# 1st Read Manual Language for Hybrids Phase 1a – Manuals 10, 14D and 18

Andrew Levitt  
Senior Lead Market Design Specialist,  
Market Design and Economics Department  
PJM Markets and Reliability Committee  
September 21, 2022

Manual 10: Pre-Scheduling Operations, Revision TBD  
Manual 14-D: Generator Operational Requirements Revisions, Revision 60  
Manual 18: PJM Capacity Market, Revision 54

### Section 4.2.3 Metering for Individual Generators

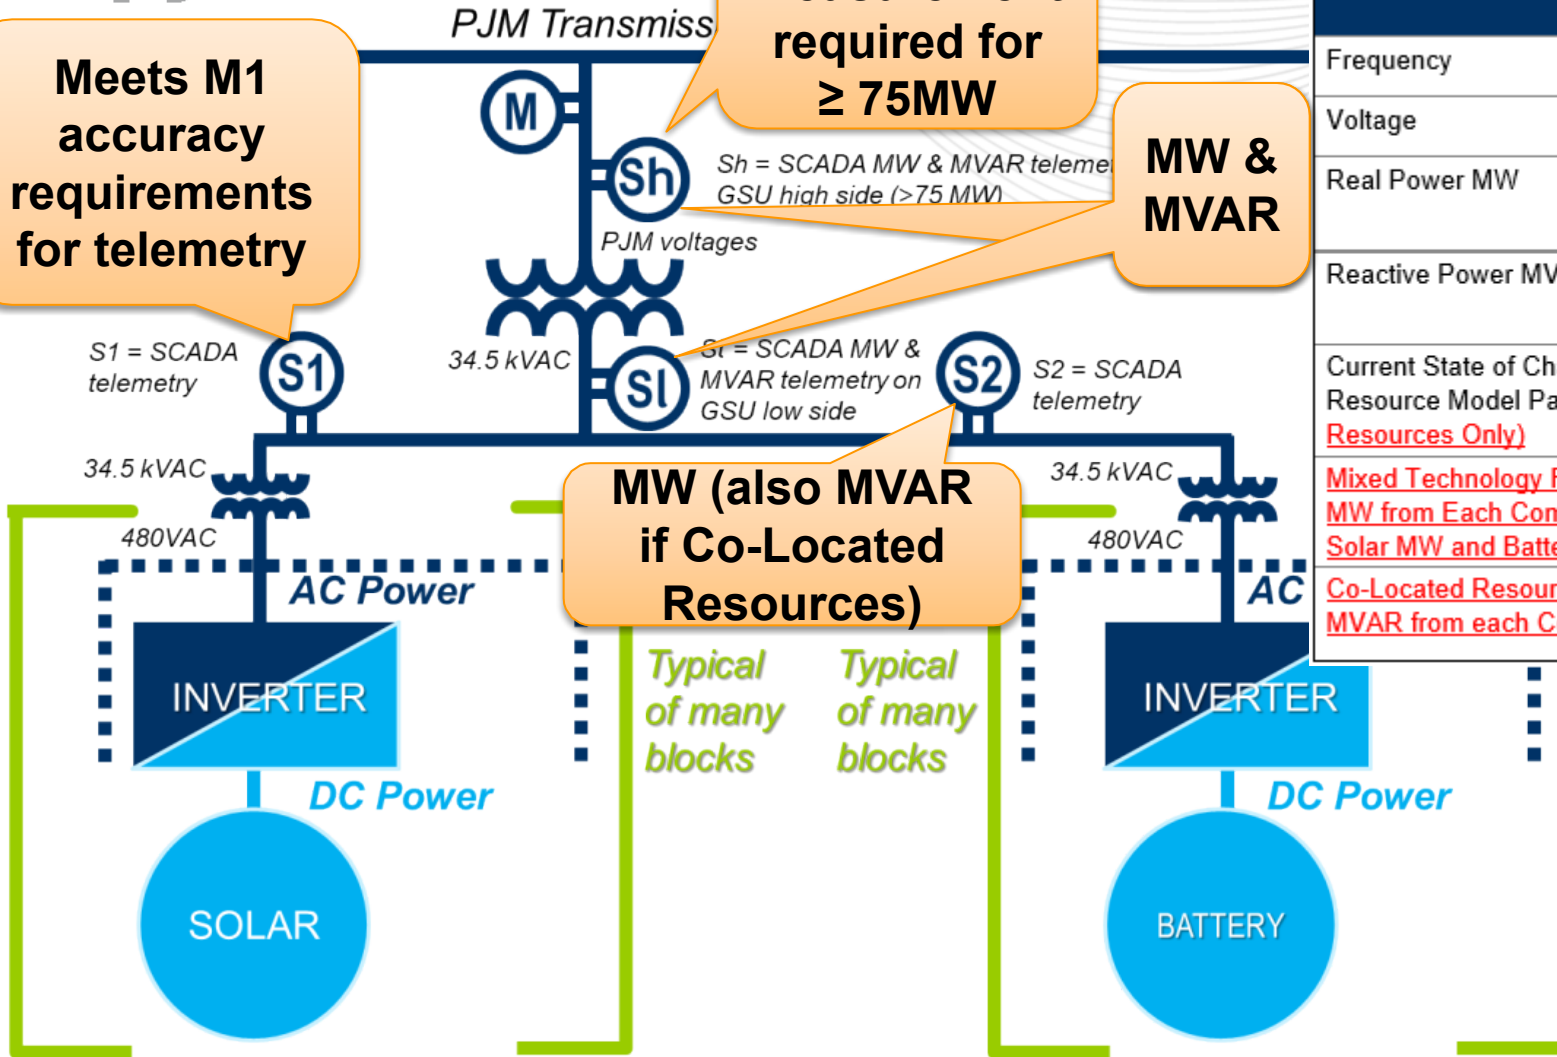
Meets M1 accuracy requirements for telemetry

Real Time Instantaneous Data Sent To PJM	
Frequency	1/1000th of HZ (i.e. 60.001 Hz)
Voltage	1/10th of kV (i.e. 69.1 kV)
Real Power MW	1 MW integer (i.e. 52 MW) required, but PJM will accept greater precision if available
Reactive Power MVAR	1 MVAR integer (i.e. 42 MVAR) required, but PJM will accept greater precision if available
Current State of Charge (Energy Storage Resource Model Participants <u>and Hybrid Resources Only</u> )	MWh remaining
<u>Mixed Technology Facilities Only—Real Power MW from Each Component Technology (e.g., Solar MW and Battery MW).</u>	<u>1 MW integer (i.e. 52 MW) required, but PJM will accept greater precision if available</u>
<u>Co-Located Resources Only—Reactive Power MVAR from each Co-Located Resource</u>	<u>1 MVAR integer (i.e. 42 MVAR) required, but PJM will accept greater precision if available</u>

Orange boxes are a summary of revision substance, see redlines for specific language

Exhibit 15: Example of inverter-based AC-coupled open-loop Hybrid Resource with 100 MW solar and 40 MW battery.

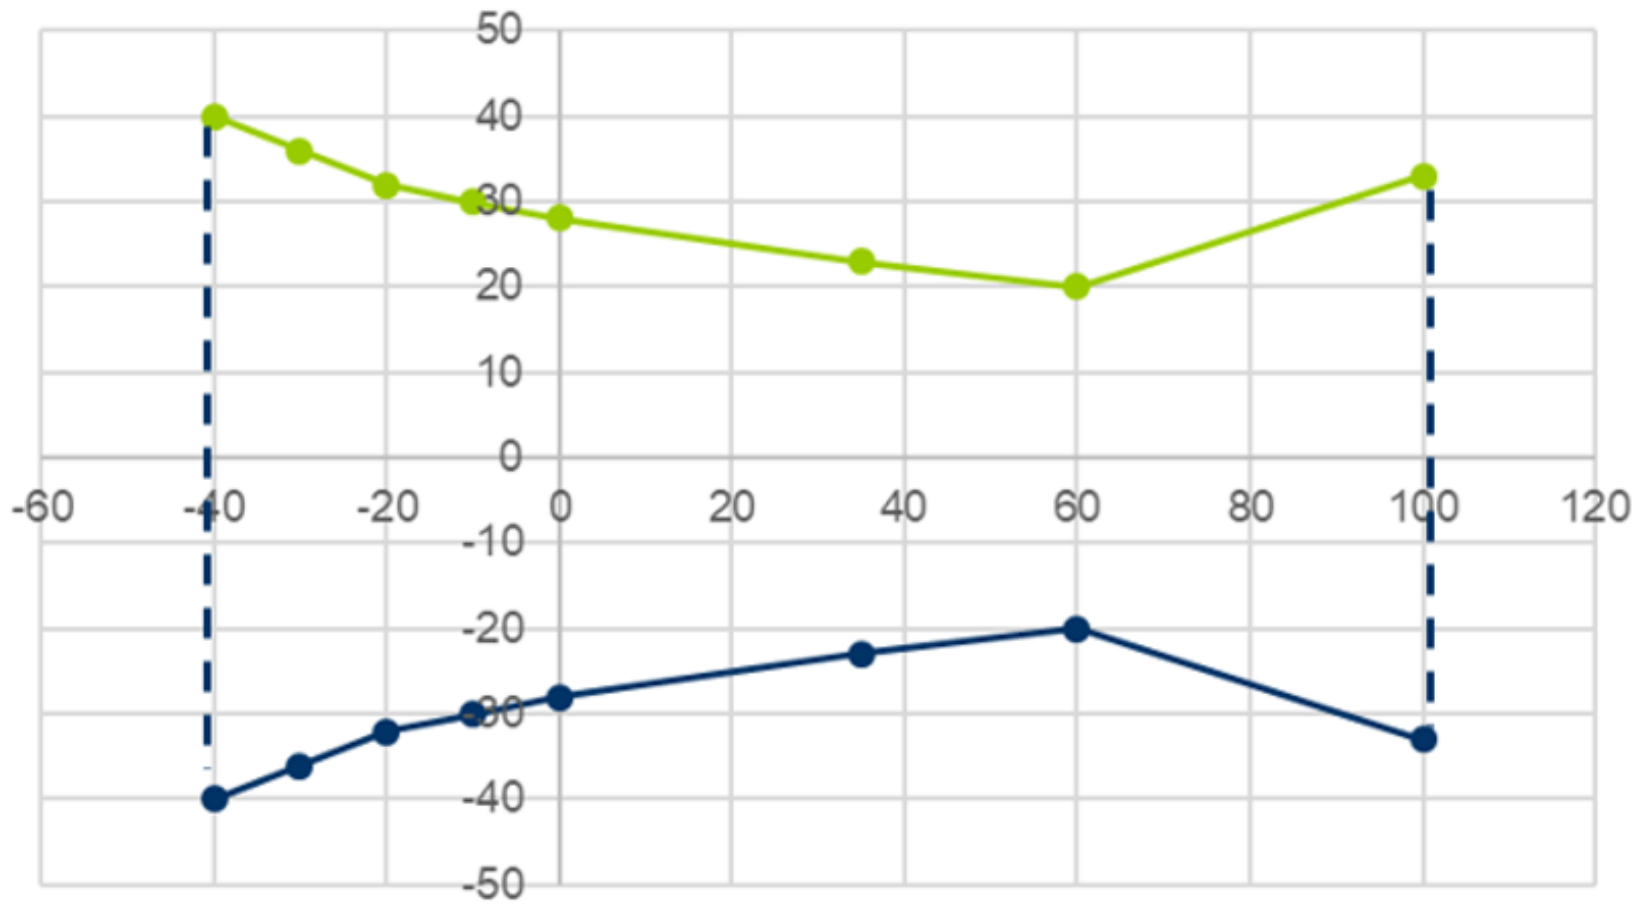
An AC-coupled Hybrid Resource has two (sets of) electrical machines (i.e., inverters), and so shows a D-curve that reflects conservative conditions.

In particular, for the solar to feed the battery, both the solar inverters and the battery inverters need to do an AC power conversion. This leaves less inverter capability available for reactive.

10. For a Hybrid Resource consisting entirely of inverter-based components, a single D-curve is tested. Such facilities are tested consistent with the provisions for inverter-based Hybrid Resources specified in the table "TESTING REQUIREMENTS SUMMARY" in Attachment E below.
11. For a Mixed Technology Facility participating in markets as multiple Co-Located Resources, multiple D-curves are tested (one D-curve for each unit at the site). For a Mixed Technology Facility not consisting entirely of inverter-based resources, one D-curve may be tested for each unit at the site.
12. For a Hybrid Resource, the composite reactive capability curve shall represent the most conservative capability of the combined Generating Facility at each net MW injection point. See examples in Figures 15 & 16 below.

Figure 16: Example of inverter-based DC-coupled open-loop solar-storage Hybrid Resource with 100 MW solar and 100 MW battery.

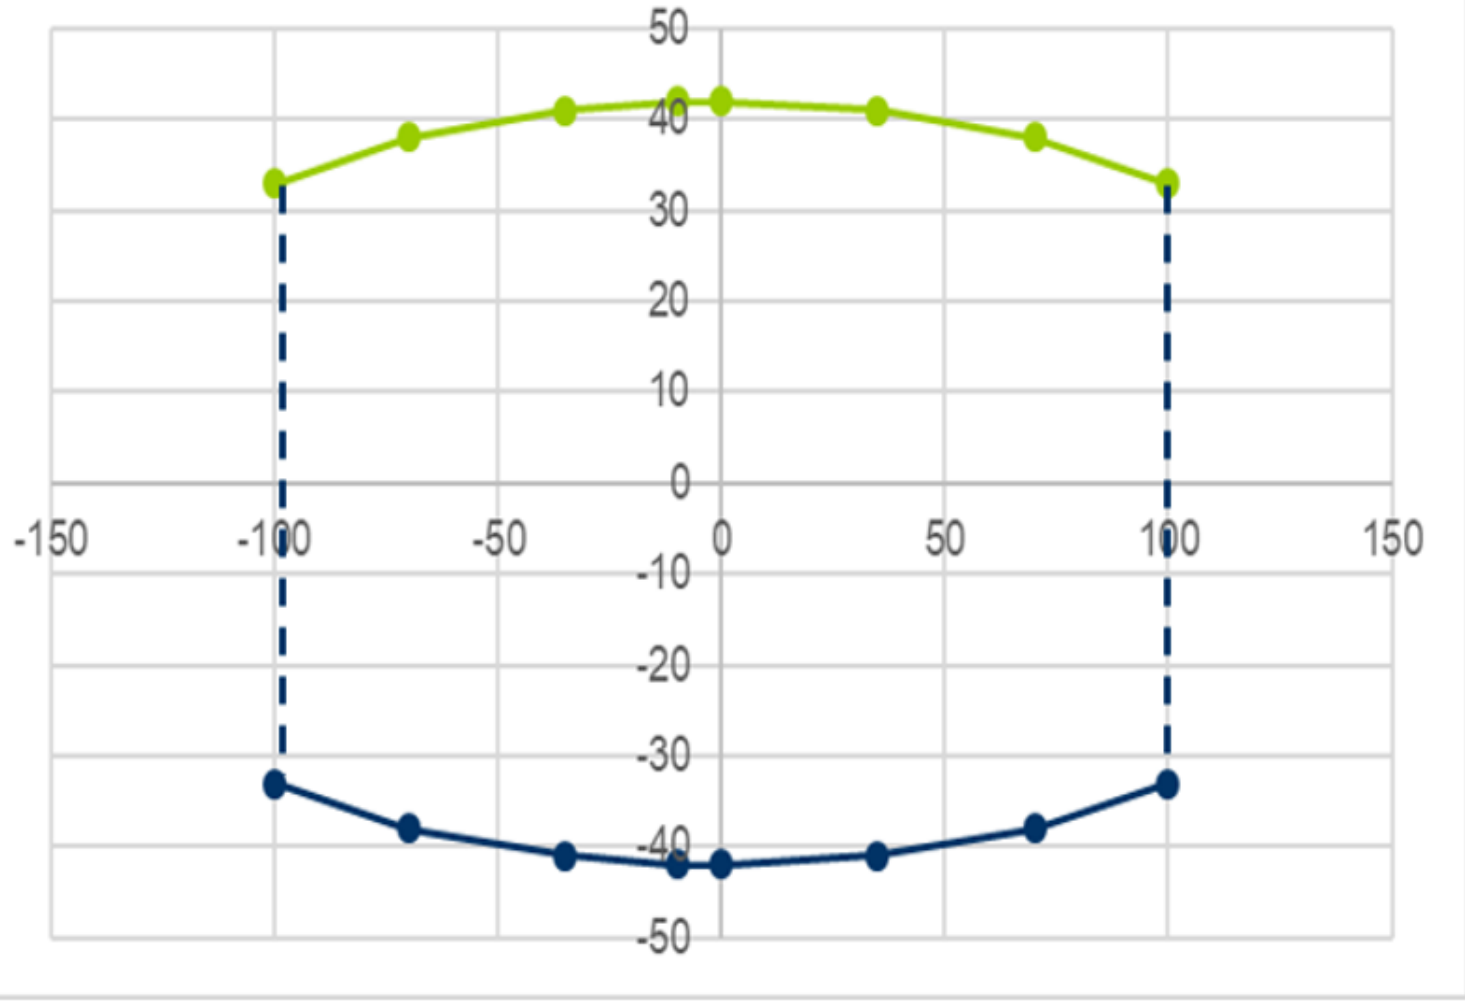
A DC-coupled Hybrid Resource has a single (set) of electrical machines (i.e., inverters), and so shows a more typical D-curve.

In particular: the solar would feed the battery directly, without needing AC power conversion. This leaves more inverter capability available for reactive.
